Access Compliance Report

Public Rights-of-Way

(Pedestrian Signals)

Intersection ID: N/A	Main Street:	Cross Street: N/A	Location: N/A
ADA ID: 3E759B5661B7	Signal Type: One Push Button-APS	Overall Compliance: No	Severity Score: BTN 1: N/A BTN 2: N/A No BTN: N/A
Codes/Mitigation Info/Possible Solution		Field Measurements/Component Compliance

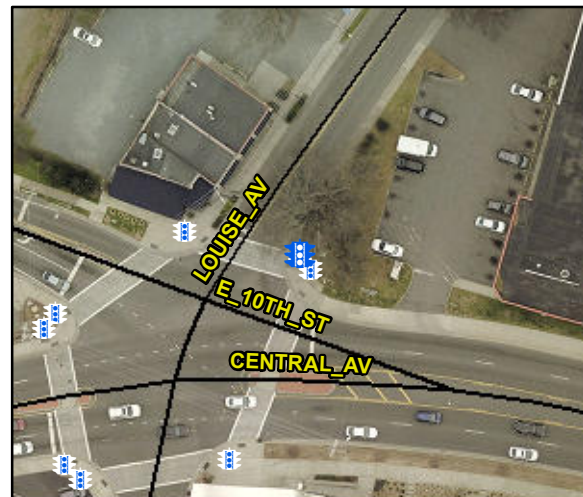
Surveyor Notes: SIGN TEXT FADED, ILLEGIBLE

PROW/ADA: , TMUTCD 4e.08, R209.1, R410.6, R404.2, R404.3, R406.2

Possible Solutions: Replace Signal Push Button With APS Button on New Post. Remove & Replace Sign.
